MHNDUnion  
Adaptable Housing Assessment Report

17-19 Sydney Road  
Manly NSW 2095

Project: 17-19 Sydney Road, Manly  
Document Type: Adaptable Housing Assessment Report  
Our Reference: P221\_387-2 (AS4299) KG

**Figure 1 - Unit type 1 (pre-adaptation)**

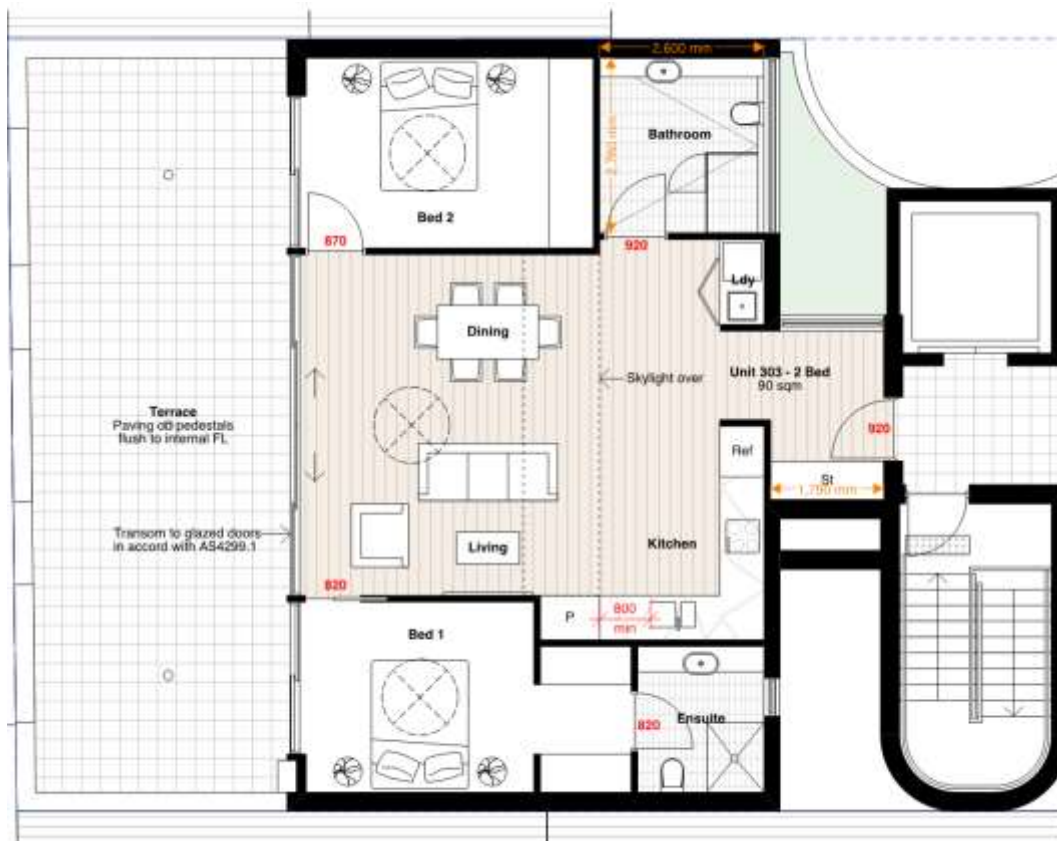
DESCRIPTION	COMMENT	RESOLUTION
Workspace – sink	Reduced workspace is proposed besides the cooktop.	Level of detail provided is suitable for DA stage. Provide minimum 800mm wide workspace besides the cooktop. Note that corner space cannot be included.
Continuous tiling	Ensure continuous tiling is proposed below all kitchen cabinets.	Level of detail provided is suitable for DA stage. As design progresses further detail will be required.

DESCRIPTION	COMMENT	RESOLUTION
Wall to be demolished	Drawings indicate internal wall is proposed to be demolished at post-adaptation to achieve required turning space at the foot of the bed.	All walls to be demolished shall be non-load bearing and free of any electrical, plumbing and other services.

DESCRIPTION	COMMENT	RESOLUTION
Floor falls	Drawings indicate floor falls at pre-adaptation differ to what is required for post-adaptation.	Ensure floor falls at pre-adaptations stage suit post-adaptation floor falls requirements.
Capped services	Capped services will be required as the sanitary fixtures are proposed to be relocated at post adaptation.	Level of detail provided is suitable for DA stage. As design progresses further detail will be required.
Walls – reinforcement	Ensure bathroom walls that are proposed to have grab-rails installed are provided with reinforcement.	Level of detail provided is suitable for DA stage. As design progresses further detail will be required.

DESCRIPTION	COMMENT	RESOLUTION
General	Doors to laundry cupboard are proposed to be removed at post-adaptation stage to allow for clear access to laundry.	Nil further action required at this stage.
